Access Compliance Report Public Rights-of-Way (Curb Ramps)

Main Street: DUSKYWING_CT Cross Street: BLUEWING_LN Location: NW

ADA ID: RPAT211029130307 Ramp Type: Type 4 - Parallel Initial Pass/Fail: Fail Overall Compliance: No Severity Score: 16

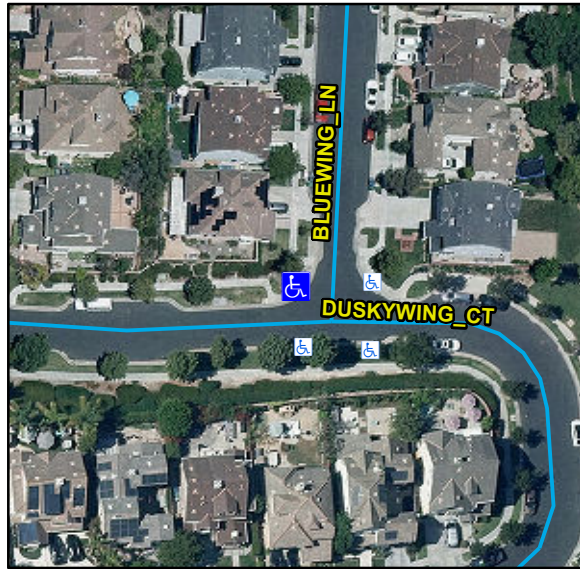
Compliance	Description	Data	Compliance	Description	Data
N/A	Ramp Length LT (in)	107	N/A	Ramp Length RT (in)	103
Yes	Ramp Width LT (in)	53	Yes	Ramp Width RT (in)	53
Yes	Ramp Run Slope LT (%)	1.7	No	Ramp Run Slope RT (%)	9.8
No	Ramp Cross Slope LT (%)	2.9	No	Ramp Cross Slope RT (%)	2.7
N/A	Landing Present	N/A	N/A	DWS Provided	N/A
N/A	Landing Length (in)	N/A	N/A	DWS Contrast	N/A
N/A	Landing Width (in)	N/A	N/A	DWS Length (in)	N/A
N/A	Landing Run Slope (%)	N/A	N/A	DWS Full Width	N/A
N/A	Landing Cross Slope (%)	N/A		DWS Offset Type	N/A
N/A	Landing Movement Obstructed?	N/A	N/A	DWS Offset Left (in)	N/A
	Landing Movement Type	N/A	N/A	DWS Offset Right (in)	N/A
N/A	Landing Shared	N/A			
N/A	Clear Space	Yes			
N/A	Clear Space To Crosswalk (in)	N/A			
N/A	Marked Crosswalk 1	No	N/A	Marked Crosswalk 2	No
	Crossing 1 Direction	S		Crossing 2 Direction	E
	Marked Crosswalk 1 Width (in)	N/A		Marked Crosswalk 2 Width (in)	N/A

Remove & Replace Curb Ramp With Two New Directional Ramps or Equivalent.

R204.3, R304.5.3, R304.3.2, STD 1115
